Proposal to renew the KOTEL AVIARY for the release of Eurasian Black vultures
January 2018, MH, JA and RN

Instruction and sketches for improvement of the release cage to be provided by VCF

The remarks are summarized in the following sketch, on basis of the dimensions provided in the email of 14/12/2017

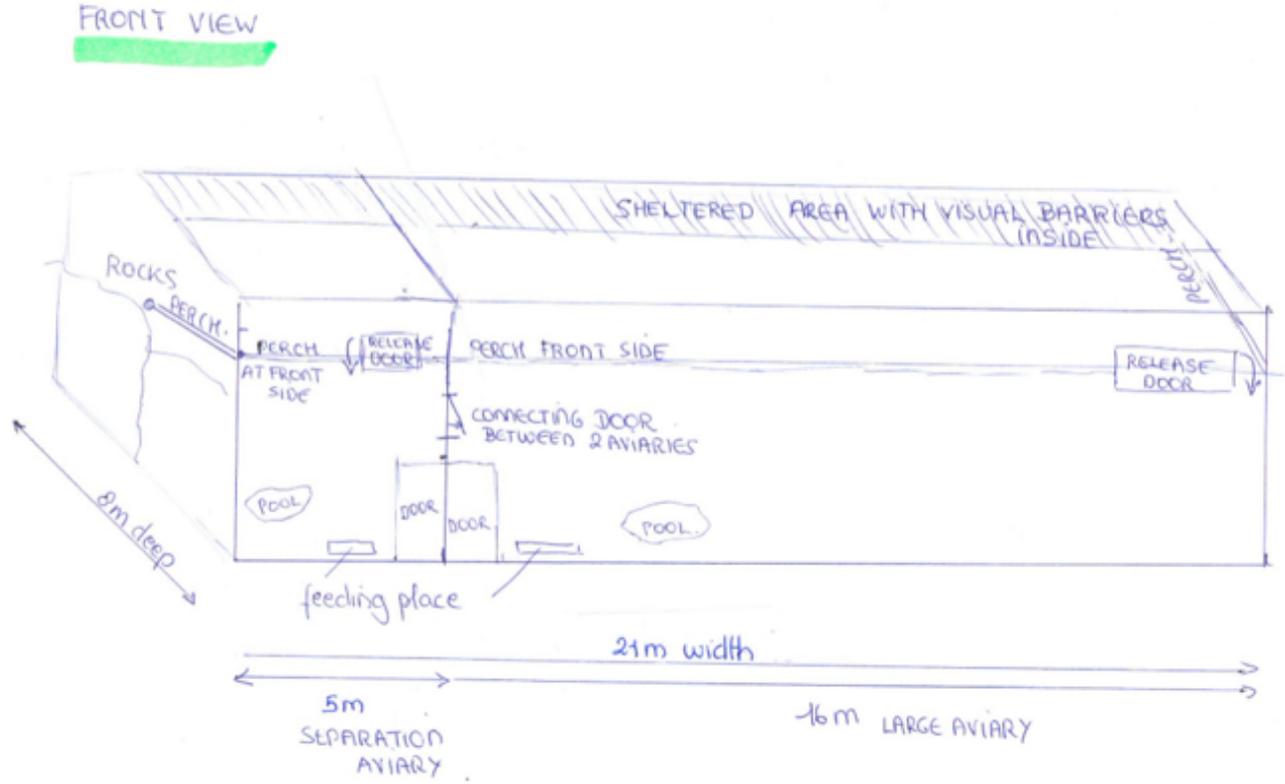
The actual aviary is being rebuilt at the moment as it was in a very bad state. During the visit in October it was discussed that:

1. Enlarge the size of the actual aviary, in particular
 - a. **make it deeper**, 2 times the actual depth, by extending it over the rocky platform
 - b. **make it higher**, with perches on 4 m high, can be up to 6 meters in the front and 2m high above the rocks

- c. **make it bigger** by adding a separate additional cage, minimum 5 m wide
 - d. **provide a sheltered area** in the back
2. **provide a bathing pool** bigger than the one which is there now, in each separation, which can be easily cleaned and provided with fresh water, at least twice a week, in summer more often.

- 210 cm x 130cm wide (oval shape) and 30-35 cm deep, with a gentle slope
 - ➔ in the bigger aviary a pool of minimum 300 x 130cm wide should be installed (oval shape and gentle slope)

3. **provide horizontal perches** in the front of the aviary -the whole length and on the sides, as high as possible, at 4m high;
 - diameter of the perches should be minimum 10 cm and of natural wood

4. **provide a release door** at the height of a perch so the bird can sit near to the open door and then go for a "soft "release (can be also on the ground)

5. provide in the back, in the sheltered area, **3 - 4 visual barriers**; make separations through the use of wooden panels; this is not required for the separation aviary; birds should be able to lie down in these shelters (rock can act as platform; if necessary, provide a platform)

6. **no use of inner poles** in each part of the aviary
7. **roof should be 3m deep**

Front View of the newly constructed aviary

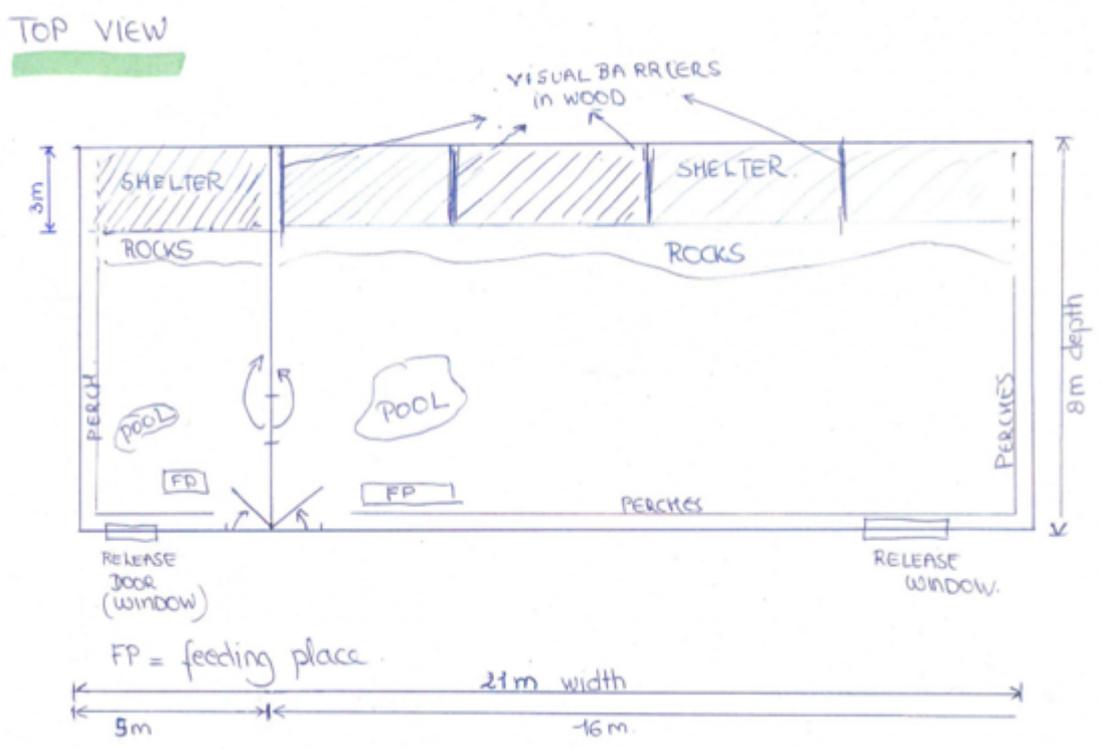
1. Construction should be strong enough to resist snow pressure → wire is installed at the inside of the metal construction

2. Use of metal wire with mesh 40 x 40 mm to prevent entrance by predators as martys and foxes
3. Put the wire of sides of the aviaries 50 cm into the ground so that predators are not able to dig a way under the sides into the aviary ; you can also extend the wire mesh on the ground and cover it with 20 cm of earth.
